# Access Audit Site Report

**Buescher State Park**

**Accessibility Evaluation**

**Inspection Date: 11/11/2021**

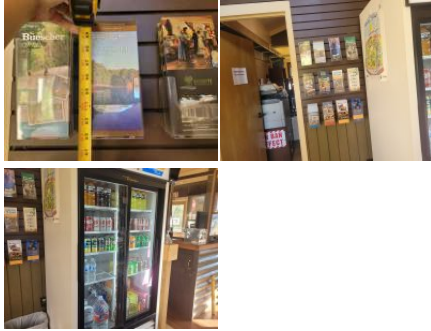
3	Headquarters: Headquarters Parking	[30.0392554 , -97.158290 8]	The running slope of walking surfaces shall not be steeper than 1:20. The cross slope of walking surfaces shall not be steeper than 1:48.	Cross slopes of 2.3%, 3%, 3.1%, and 3.4%, and running slopes of 9%, 6.5%, and 5.7%	Correct running slopes to max 5% and cross to max 2.08%.	2012 TAS Section: 403.3  2010 ADAS Section: 403.3

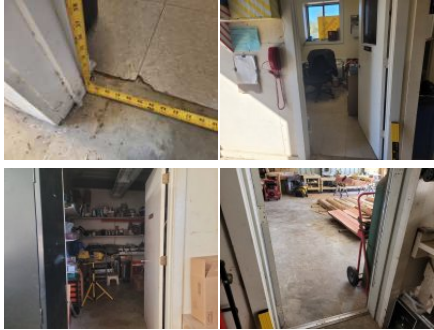
Finding Number	Area Description	Lat/Long	Finding	As Built	Recommendation	Citation	Photos	Figure
22	Employee Spaces: Maintenance Building	[30.044015, -97.157889 5]	There are no accessible parking stalls. Each lot where parking is provided for the public as clients, guests or employees, shall provide accessible parking and shall be located on the shortest accessible route of travel from adjacent parking to an accessible entrance. There are a total of 10 parking stalls in the parking lot that could be reasonably associated with this facility. There should be a minimum of 1 accessible stalls with a minimum of 1 being designed as van accessible.	Lacks accessible parking stalls (approximately 10 standard, 0 accessible)	Create one or more 8' accessible parking stalls, with one 5' adjacent access aisle, with proper signage and striping based on the total number of stalls	2015 ABAAS Section: F208.2  2012 TAS Section: 208.2  2010 ADAS Section: 208.2

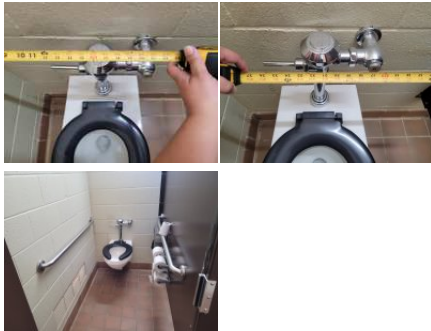
67	Cozy Circle Camping Area: Cozy Circle Camping Area Men's Restroom	[30.0471332 , -97.159806 3]	The grab bar height and/or spacing fails. Grab bars must be mounted between 33" and 36" to the top of the gripping surface. There must be 1.5" of clearance between the grab bar and the wall. There must be a minimum of 1.5" of clearance below and minimum 12" above the grab bar to any dispenser or other obstruction.	Gripping surfaces of grab bars are 36.75" aff	Remount grab bars in accessible stall to 33" to 36" aff	2015 ABAAS Section: 609.3, 609.4  2012 TAS Section: 609.4, 609.3  2010 ADAS Section: 609.3, 609.4

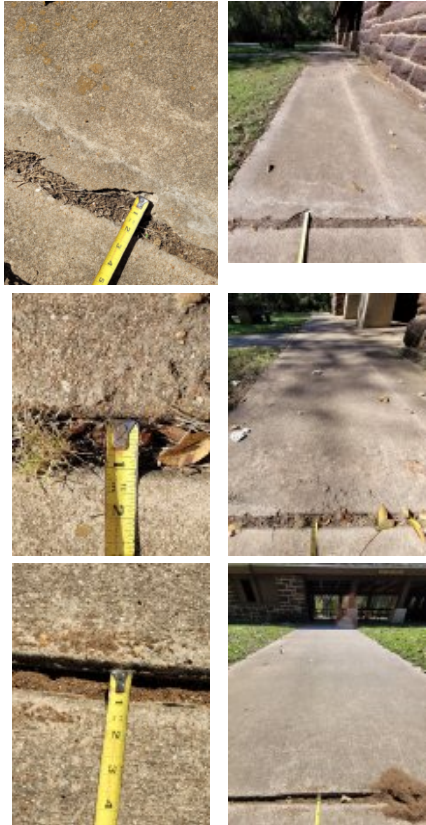
131	Lakeview Camping Area: Lakeview Camping Area Women's Shower	[30.0483266 , -97.161657]	Grab bars shall be installed in a horizontal position, 33 inches (840 mm) minimum and 36 inches (915 mm) maximum above the finish floor measured to the top of the gripping surface	Gripping surfaces of grab bars are 37" aff	Remount shower grab bar to 33" min. and 36" max. AFF.	2015 ABAAS Section: 609.3 Exception, 609.4  2012 TAS Section: 609.4, 609.3 Exception  2010 ADAS Section: 609.4, 609.3 Exception

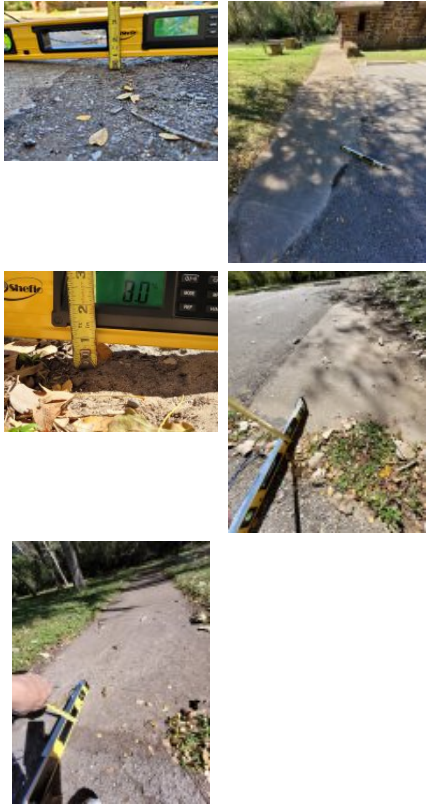
133	Lakeview Camping Area: Lakeview Camping Area Accessible Site 52	[30.0483545 , -97.161500 1]	Picnic tables shall provide at least one wheelchair space for each 24 linear feet (7320 mm) of usable table surface perimeter. Wheelchair spaces shall be 30 inches (760 mm) minimum by 48 inches (1220 mm) minimum. Wheelchair spaces shall be positioned for a forward approach to the table and provide knee and toe clearance complying with 306 under the table	Lacks picnic table of an accessible design	Replace picnic table with one of an accessible design as a smart practice	2015 ABAAS Section: 1011.4.2		
134	Lakeview Camping Area: Lakeview Camping Area Accessible Site 52	[30.0483104 , -97.161548 4]	Where provided, cooking surfaces shall be 15 inches (380 mm) minimum and 34 inches (865 mm) maximum above the ground	Cooking surface of low grill/fire ring 13" at highest setting	Raise or lower cooking surface to be 15" min to 34" max above the ground; in the alternative, replace with a compliant surface as a smart practice	2015 ABAAS Section: 1011.5.2

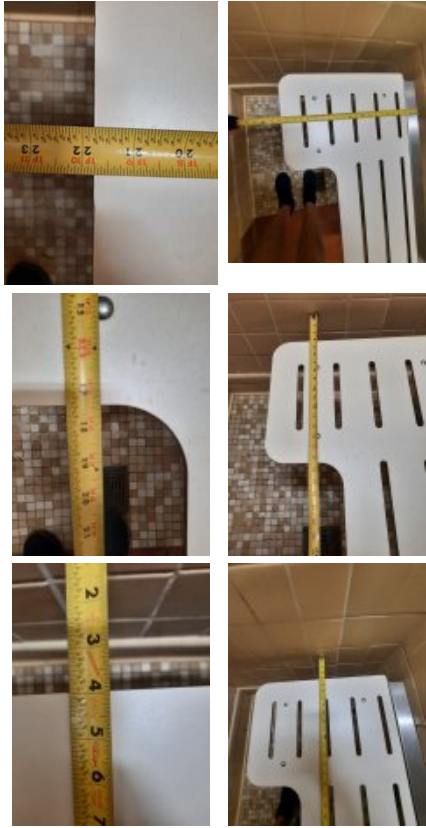
Finding Number	Area Description	Lat/Long	Finding	As Built	Recommendation	Citation	Photos	Figure
158	Oak Haven Camping Area: Oak Haven Camping Area Women's Restroom	[30.0441277 , -97.161926 6]	The water and drain pipes under the lavatory are not adequately insulated. Water supply and drain pipes under lavatories and sinks shall be insulated or otherwise configured to protect against contact. There shall be no sharp or abrasive surfaces under lavatories and sinks.	Sink lacks insulated pipes	Insulate exposed pipes under one sink	2015 ABAAS Section: 606.5  2012 TAS Section: 606.5  2010 ADAS Section: 606.5		
159	Oak Haven Camping Area: Oak Haven Camping Area Women's Restroom	[30.0441195 , -97.161929 3]	Where a high forward reach is over an obstruction, the clear floor space shall extend beneath the element for a distance not less than the required reach depth over the obstruction. The high forward reach shall be 48 inches (1220 mm) maximum where the reach depth is 20 inches (510 mm) maximum. Where the reach depth exceeds 20 inches (510 mm), the high forward reach shall be 44 inches (1120 mm) maximum and the reach depth shall be 25 inches (635 mm) maximum. Where a clear floor or ground space allows a parallel approach to an element and the high side reach is over an obstruction, the height of the obstruction shall be 34 inches (865 mm) maximum and the depth of the obstruction shall be 24 inches (610 mm) maximum. The high side reach shall be 48 inches (1220 mm) maximum for a reach depth of 10 inches (255 mm) maximum. Where the reach depth exceeds 10 inches (255 mm), the high side reach shall be 46 inches (1170 mm) maximum for a reach depth of 24 inches (610 mm) maximum.	Coat hook 52" aff, soap dispenser 59" aff, and paper towel dispenser 63" aff	Lower operating mechanisms to max 48" above the finished floor (AFF) to highest operable part. Lower operable parts to max 44" above the finished floor (AFF) for a forward reach over sink.	2015 ABAAS Section: 308.2.1, 308.3.2  2012 TAS Section: 308.2.1, 308.3.2  2010 ADAS Section: 308.2.1, 308.3.2

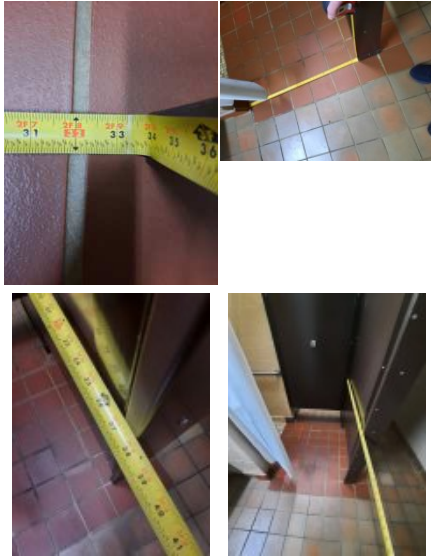
162	Oak Haven Camping Area: Oak Haven Camping Area Women's Restroom	[30.0441149 , -97.161923 9]	The toilet is not located within the range to the side wall or partition. The centerline of the toilet shall be 17 inches minimum and 19 inches maximum side wall or partition in the ambulatory accessible toilet compartment.	Centerline of the toilet is 20" from the partition	Remount toilet to 17" to 19" from the side wall to center line in ambulatory stalls	2015 ABAAS Section: 604.9.1  2012 TAS Section: 604.9.1  2010 ADAS Section: 604.9.1

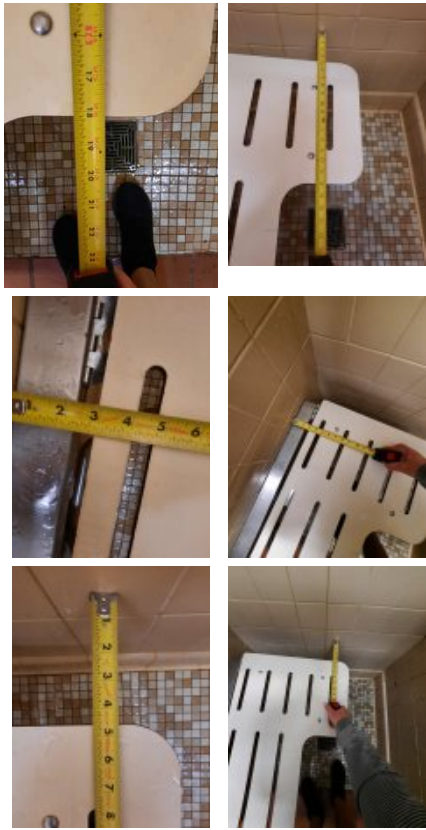
165	Oak Haven Camping Area: Oak Haven Camping Area Men's Shower	[30.0441195 , -97.161934 6]	Transfer type shower compartments shall be 36 inches (915 mm) by 36 inches (915 mm) clear inside dimensions measured at the center points of opposing sides and shall have a 36 inch (915 mm) wide minimum entry on the face of the shower compartment. Clearance of 36 inches (915 mm) wide minimum by 48 inches (1220 mm) long minimum measured from the control wall shall be provided.	transfer shower 34.75" wide	Enlarge transfer shower to compliant 36" by 36" clear inside dimension	2015 ABAAS Section: 608.2.1  2012 TAS Section: 608.2.1  2010 ADAS Section: 608.2.1		 <small>Note: make transfer shower a minimum at the center points of opposing sides</small>

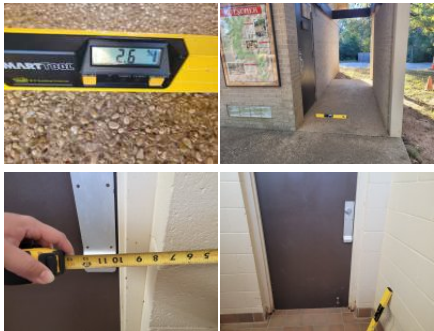
Finding Number	Area Description	Lat/Long	Finding	As Built	Recommendation	Citation	Photos	Figure
188	Day Use Area: Day Use Group Picnic Area	[30.0426576 , -97.158187 8]	Area was closed at time of audit.	area closed at time of audit	Ensure that amenities are fully compliant when area is reopened for public use.	Capture Section: 1		
189	Day Use Area: Day Use Area Men's Restroom	[30.0440685 , -97.158795 1]	The restroom sign does not comply with one or more applicable requirements for the location, height, and properties of the sign.	Lacks compliant signage	Acquire and mount signage, including Braille and access symbol mounted on wall, latch side of door, 48" to baseline of lowest character and 60" to baseline of highest character	2015 ABAAS Section: F216.2, 703.1, 703.2, 703.5, 703.6  2012 TAS Section: 216.2, 703.1, 703.2, 703.5, 703.6  2010 ADAS Section: 216.2, 703.1, 703.2, 703.5, 703.6

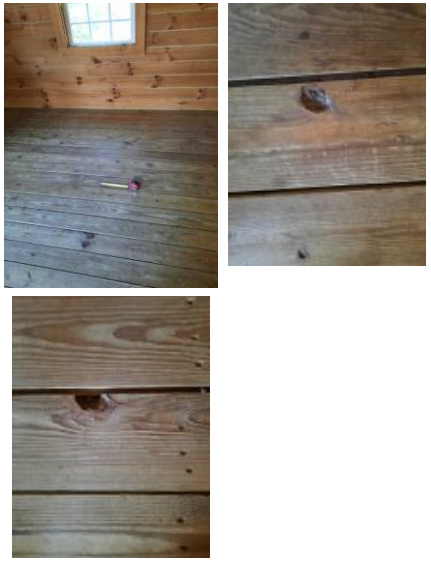
211	Day Use Area: Day Use Area Women's Restroom	[30.0440592 , -97.158799 1]	There is insufficient turning space within this room or space. The space required for a wheelchair to make a 180-degree turn is a clear space of 60 inches in diameter or a T-shaped space.	Lacks sufficient turning space within this room or space	Renovate restroom to provide 60" turning space	2015 ABAAS Section: 304.3.1, 304.3.2  2012 TAS Section: 304.3.1, 304.3.2  2010 ADAS Section: 304.3.1, 304.3.2		
212	Day Use Area: Day Use Area Parking (along Park Road 1E)	[30.0442484 , -97.158588 6]	The cross slopes (narrow dimension) and/or running slopes (long dimension) of the access aisle exceeds 2%. The running slope and the cross slope in an accessible parking stall and the access aisle must not exceed 2%.	Slopes of 2.3% in right stall and 3.2% in access aisle	Repair or correct slope of parking space and access aisle to max 2.08% in any direction.	2015 ABAAS Section: 502.4  2012 TAS Section: 502.4  2010 ADAS Section: 502.4

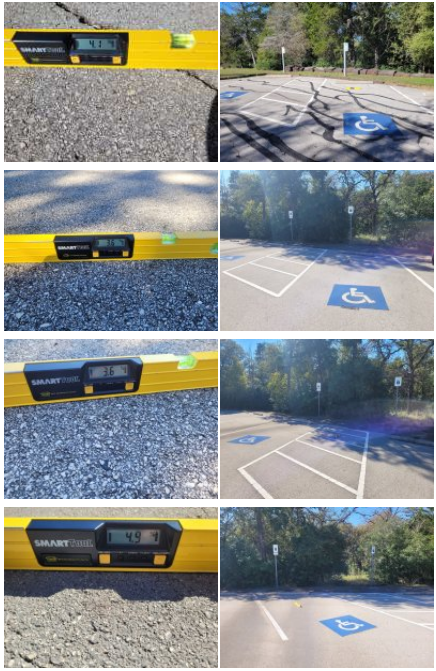
Finding Number	Area Description	Lat/Long	Finding	As Built	Recommendation	Citation	Photos	Figure
246	Day Use Area: Day Use Area Accessible Screen Shelter 1	[30.0450456 , -97.159553]	There is no accessible route to the exterior outlet. At least one accessible route shall connect accessible buildings, accessible facilities, accessible elements, and accessible spaces that are on the same site.	Lacks accessible route to exterior outlet	Create an accessible route with crushed stone or other outdoor material from parking or walkway to the exterior outlet	2015 ABAAS Section: F206.2.2  2012 TAS Section: 206.2.2  2010 ADAS Section: 206.2.2		
247	Day Use Area: Day Use Area Central Picnic Areas	[30.04373, -97.159]	There is a gap spaced greater than a 1/2 inch. Openings in floor or ground surfaces shall not allow passage of a sphere more than 1/2 inch diameter. Elongated openings shall be placed so that the long dimension is perpendicular to the dominant direction of travel.	Gaps of 1" near shelter 4, 1.25", two 1" gaps between shelter and restrooms, gap up to 5" at restroom, and 1.5" at women's restroom	Correct or fill gaps to be max .5"	2015 ABAAS Section: 302.3  2012 TAS Section: 302.3  2010 ADAS Section: 302.3

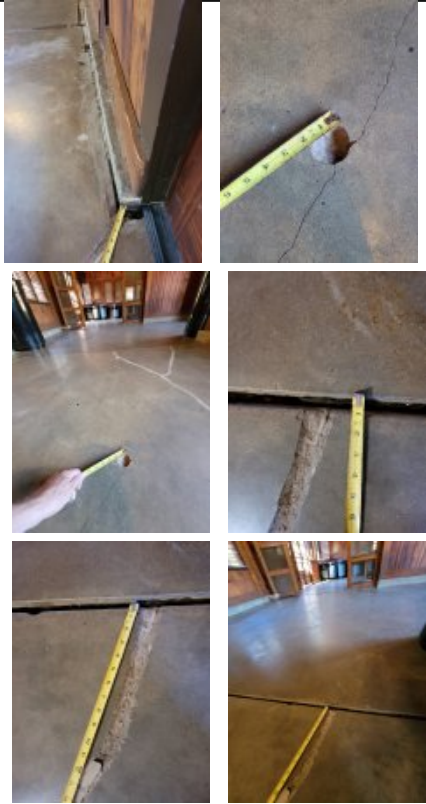
Finding Number	Area Description	Lat/Long	Finding	As Built	Recommendation	Citation	Photos	Figure
260	Day Use Area: Day Use Area Group Recreation Hall	[30.0455405 , -97.160027 6]	Changes in level of ¼ inch (6.4 mm) high maximum shall be permitted to be vertical Changes in level between ¼ inch (6.4 mm) high minimum and ½ inch (13 mm) high maximum shall be beveled with a slope not steeper than 1:2. Changes in level greater than ½ inch (13 mm) high shall be ramped, and shall comply with 405 or 406.	Main room doors, patio side - CIL of 1"	Repair, bevel or ramp CIL at doorway	2015 ABAAS Section: 303.3, 404.2.5, 303.2, 303.4  2012 TAS Section: 303.3, 404.2.5, 303.2, 303.4  2010 ADAS Section: 303.3, 404.2.5, 303.2, 303.4

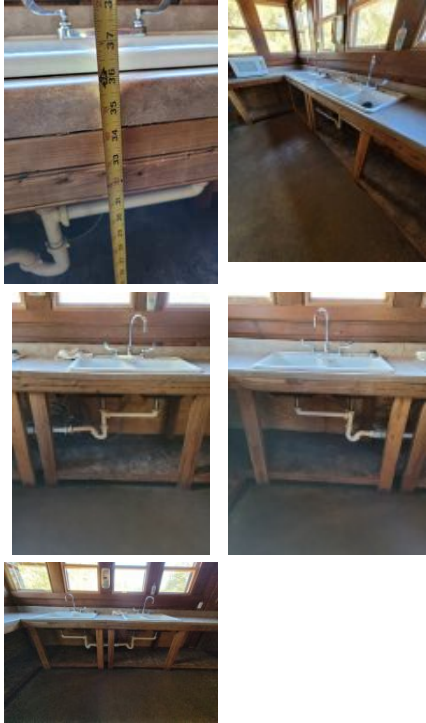
264	Day Use Area: Day Use Area Group Recreation Hall	[30.0455335 , -97.160038 3]	It is recommended that exterior doors be maintained so that the operating pressure does not exceed 8.5 lb. force to open.	Main room doors, parking lot side - Exterior door - left door - 19 lbf required, right door 15 lbf required	For all doors along the public circulation route, inspect, adjust, and maintain 8.5 lbf to open exterior doors as a smart practice	2012 TAS Section: 404.2.9, 404.2.9 Advisory, 404.2.8.1  2010 ADAS Section: 404.2.9, 404.2.8.1		
265	Day Use Area: Day Use Area Group Recreation Hall	[30.0455359 , -97.160043 7]	The elements projects more than 4 inches into the circulation path. Wall-mounted objects that have leading edges between 27 inches and 80 inches from the floor must not project more than 4 inches into the circulation path. Protruding objects that extend to the floor or within 27 inches of the floor are cane detectable and are therefore not hazardous. Where it is necessary or desirable to have objects protrude from the wall, a manner of cane detection must be provided.	main room- wall sconces protrude 7" and mantel protrudes 9"	Relocate protruding objects or place cane detectable warning or bollard at foot of item	2015 ABAAS Section: 307.2  2012 TAS Section: 307.2  2010 ADAS Section: 307.2

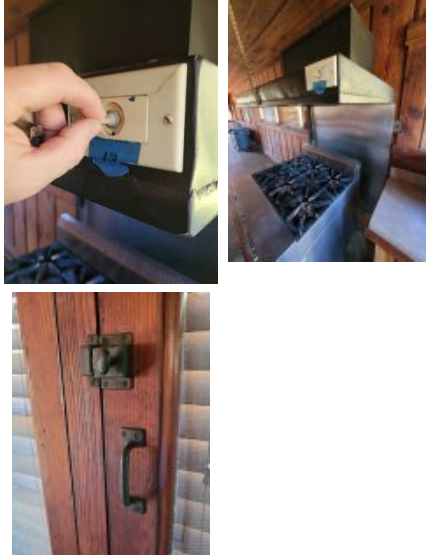
Finding Number	Area Description	Lat/Long	Finding	As Built	Recommendation	Citation	Photos	Figure
268	Day Use Area: Day Use Area Group Recreation Hall	[30.0455428 , -97.160047 7]	The elements are positioned too high for either a side or front approach. Where a clear floor or ground space allows a parallel approach to an element and the side reach is unobstructed, the high side reach shall be 48 inches maximum and the low side reach shall be 15 inches minimum above the finish floor or ground. Where a forward reach is unobstructed, the high forward reach shall be 48 inches maximum and the low forward reach shall be 15 inches minimum above the finish floor or ground.	main room- light switch 62" aff and fire extinguisher 66" aff	Remount operable parts to be in reach range of 15" min to 48" max	2015 ABAAS Section: 308.1  2012 TAS Section: 308.1  2010 ADAS Section: 308.1
